Peer Review File

Volcaniclastic density currents explain widespread and diverse seafloor impacts of the 2022 Hunga Volcano eruption

REVIEWER COMMENTS

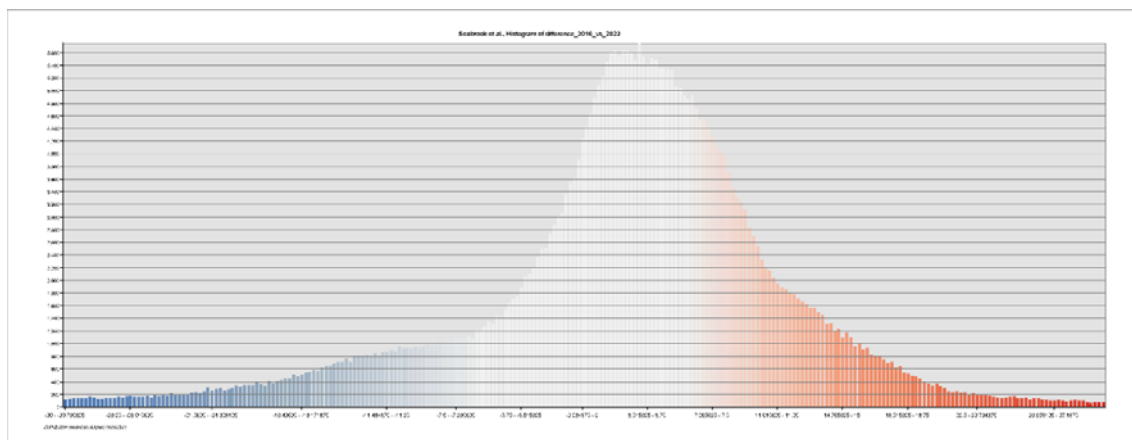
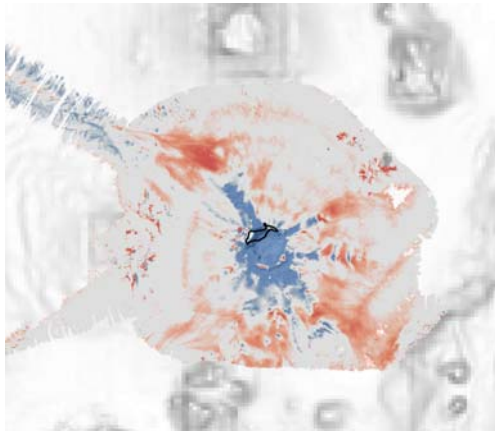
Figure 2 This is a great figure that gives a very nice view of how density currents progressed and evolved. There is no description of the methods used to make the difference map or uncertainty associated with the estimates. There is clearly some error associated with rough terrain on features that are known not have changed, such as flank domes, that can arise from minor navigation offsets. It looks like that difference may not be stochastic (i.e., distributed around zero), but has a somewhat positive. It would be worth taking a look at the net gain/loss in areas that are known to not have changed to make sure the gain/loss is not biased. I'm also a little dubious of the spur to the NW, where pre-eruption data is sparse. There seems to be patterns in the gain/loss that look more like artifacts than real signal. I would be careful interpreting that and it may be better to leave it out of the analysis.

Rev 2 is correct that the color range we previously used was heavier on the gain, and so we have adjusted the color bar to be evenly distributed about zero. Additionally, the neutral color that was used in the previous figure to show no change was a warmer color that appeared to be more towards the orange side and skewed the image. We have corrected this. If you view the histogram included below you can see that the gain/loss appears roughly evenly distributed and does not appear to be biased.

Additionally, in the manuscript, we speak mostly of qualitative morphological change, not quantitative change. The only quantification that we provide is on the order of cubic kilometers. In this case, the error associated with the echosounders, even in the most erroneous scenarios, would be 1% of that quantification. The maximum error in the deepest portion of our survey area (associated with echosounder error) would be 2m vertically, and in the shallowest portions of our
